PLANNING BOARD MEETING

Lansing Town Hall Board Room
Monday, February 24, 2025
6:30 PM

c. **Project:** Site Plan Review - Cellular Communications Tower located at 1767 E. Shore Drive

RE: Application for a use variance from the Zoning Board of Appeals and site plan approval from the Planning Board by Bell Atlantic Mobile Systems LLC d/b/a Verizon to construct and operate a 145' wireless telecommunications tower (plus 4' lightning rod) and associated improvements on land owned by Community Rec Center Inc. located near 1767 East Shore Drive (S.B.L. # 37.1-6-9) in the Town of Lansing, Tompkins County, New York (Verizon "Reach Run" site)

C.E. JOB NUMBER: **7969**
SHEET NUMBER: **LA100**

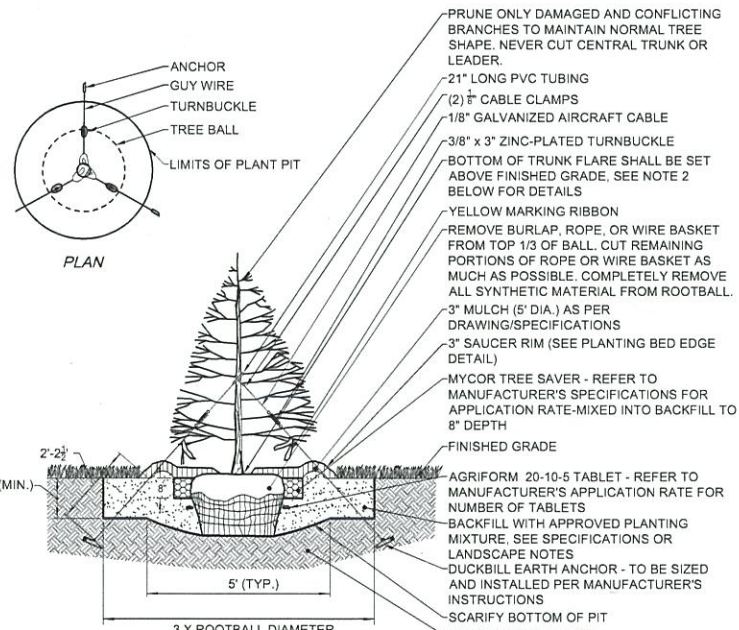
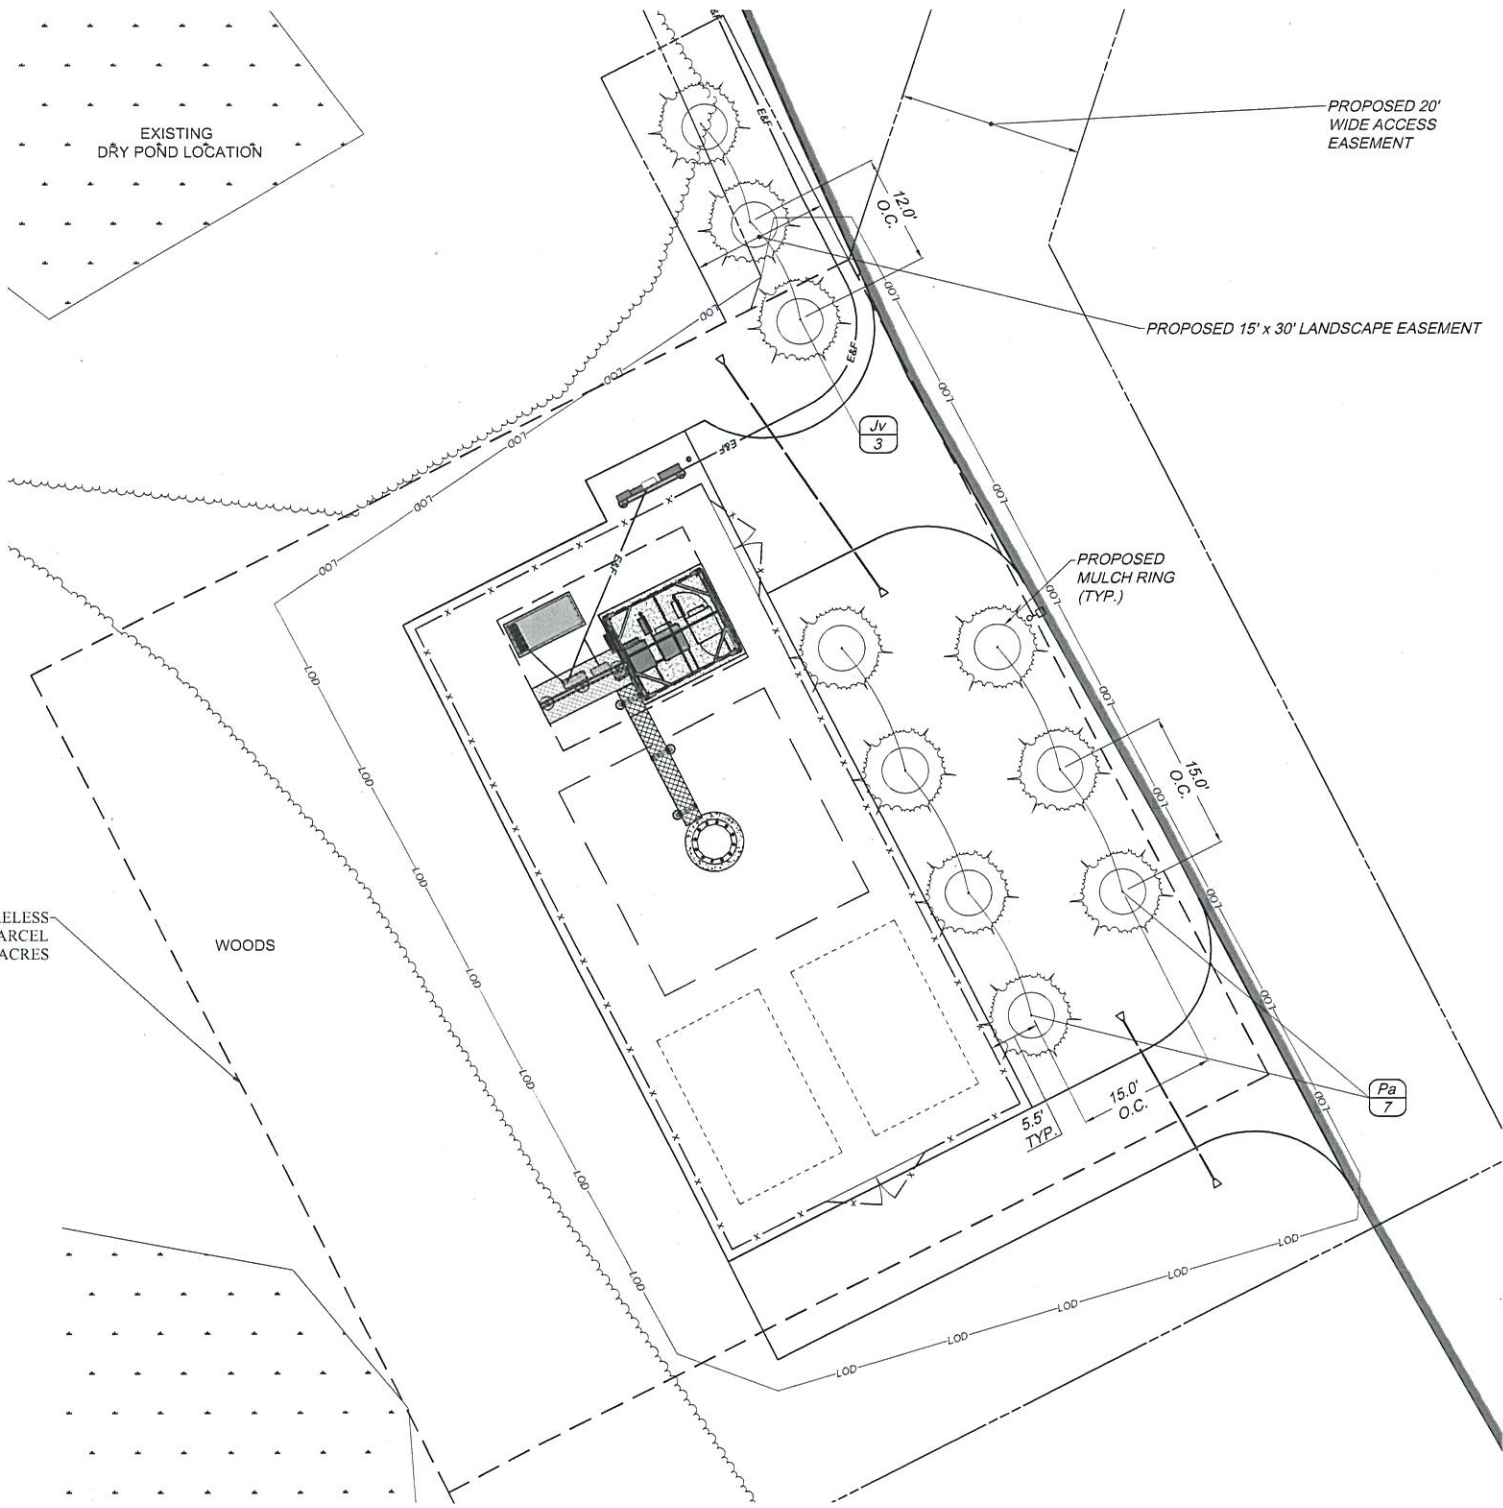
4. ***Note 5 on Sheet LA100 states that trees should be located a minimum of five (5) feet from utilities. However, the trees proposed to the north of the tower are shown less than five (5) feet from the utility. Please clarify.***

Note 5 on Sheet LA100, as shown on the Revised Plan enclosed as Exhibit U, has been clarified to read "THE CONTRACTOR IS HEREBY NOTIFIED THAT UNDERGROUND UTILITIES EXIST. SHOULD LOCATION OF TREES BE WITHIN 5' OF UNDERGROUND UTILITIES, RELOCATE SAID TREES TO A MINIMUM OF 5' FROM BALL TO UTILITIES."
